**Addendum 2**  
**Solicitation 23-99776**  
**GANC Connector Trail, Snowmaking & Lighting**

This addendum serves to notify all bidders of the following changes to the solicitation documents:

1 POWER LAYOUT  
1" = 100'-0"

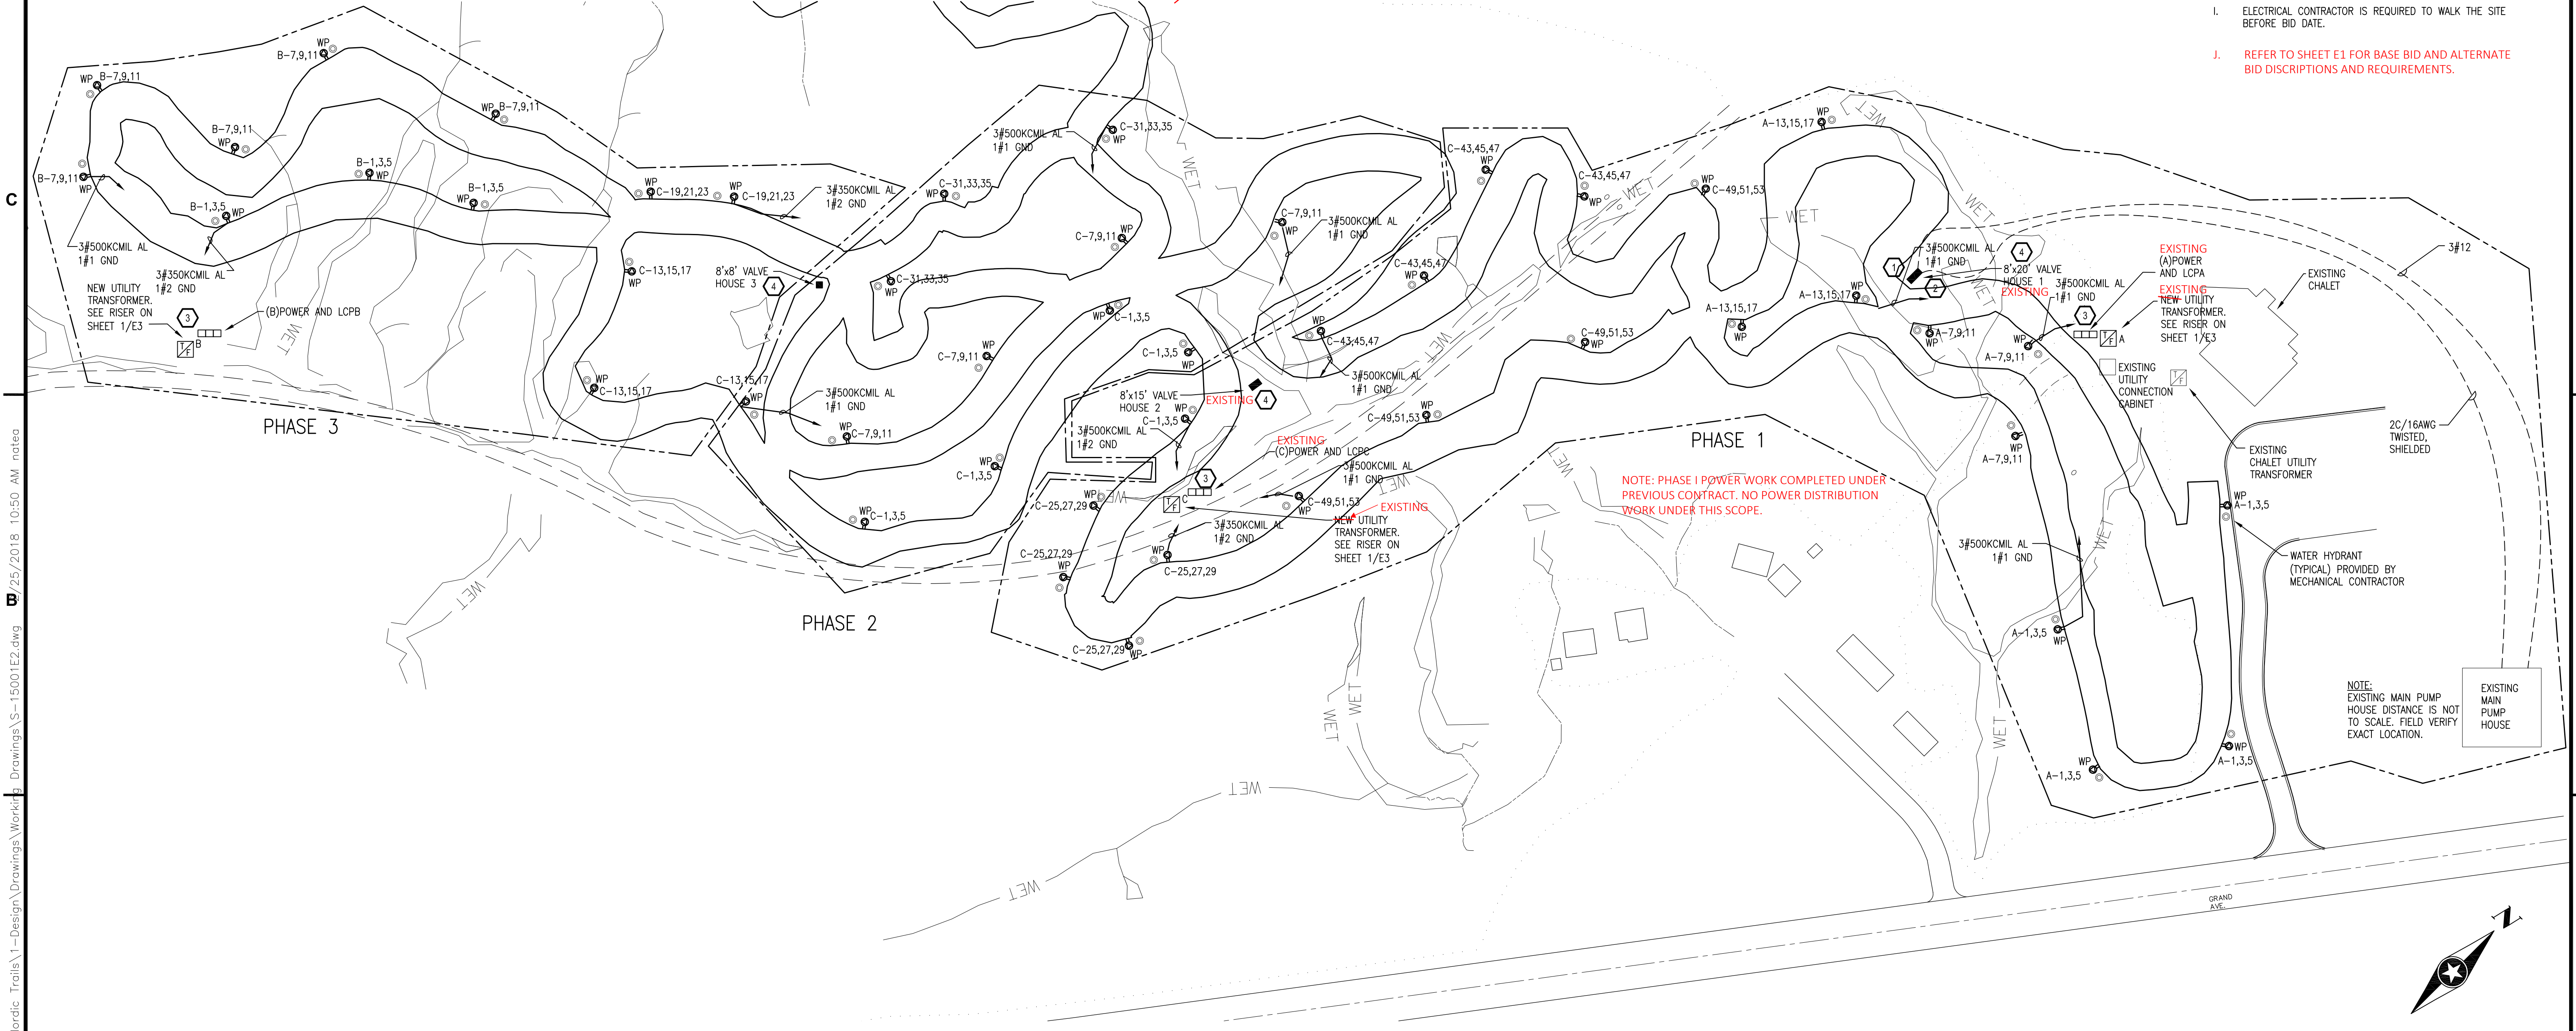
**ADD ALTERNATE #5 TO INCLUDE:**  
 ALL ABOVE GROUND SNOWMAKING POWER INFRASTRUCTURE FOR PHASE 2 (1.0K) LOOP. PROVIDE ALL ELECTRICAL PEDESTALS AND ASSOCIATED ELECTRICAL. INCLUDE A UNIT PRICE TO INSTALL ELECTRICAL PEDESTAL.

**ADD ALTERNATE #6 TO INCLUDE:**  
 ALL ABOVE GROUND SNOWMAKING POWER INFRASTRUCTURE FOR PHASE 3 (0.8K) LOOP. PROVIDE ALL ELECTRICAL PEDESTALS AND ASSOCIATED ELECTRICAL. INCLUDE A UNIT PRICE TO INSTALL ELECTRICAL PEDESTAL.

**ADD ALTERNATE #7 TO INCLUDE:**  
 ALL ABOVE GROUND LIGHTING AND LIGHTING CONTROLS INFRASTRUCTURE FOR PHASE 1, 2 AND 3 (3.3K TOTAL) LOOP. PROVIDE POLE, BASE, ASSOCIATED ELECTRICAL AND INSTALL LIGHT FIXTURES. PROVIDE LIGHTING CONTROLS TO COMPLETE SYSTEM. INCLUDE A UNIT PRICE TO INSTALL WOOD AND METAL POLES.
